RFQ Question and Answer List

Project Name Ross Heart Hospital – Roof Replacement Project Number OSU-265396
Project Location Ohio State University

Date posted: 03.18.2026

Roof

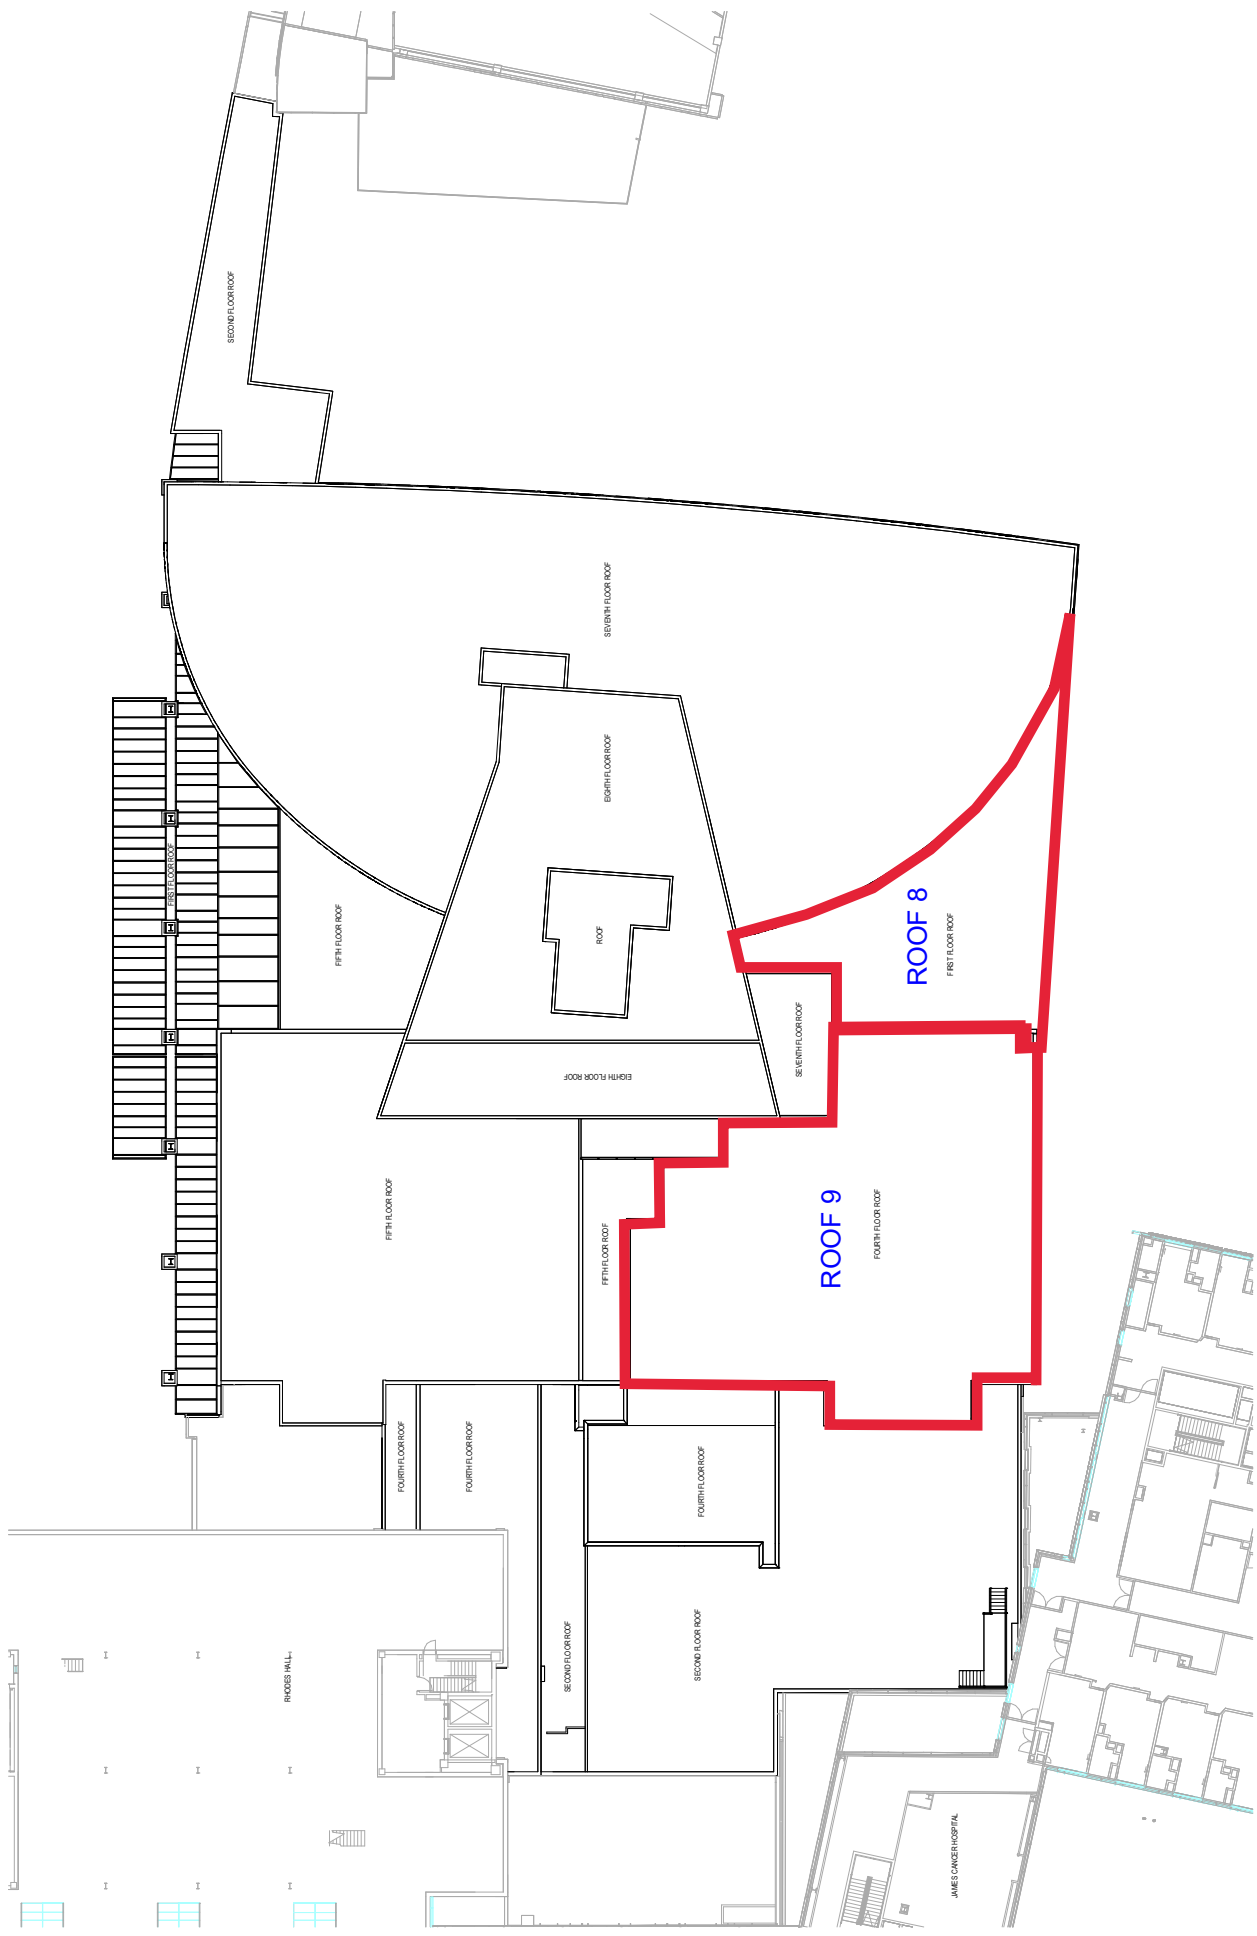
1. Is it possible to find out which areas of the Ross Heart building roof are areas 8 and 9?

A. Please see attached roof plan.
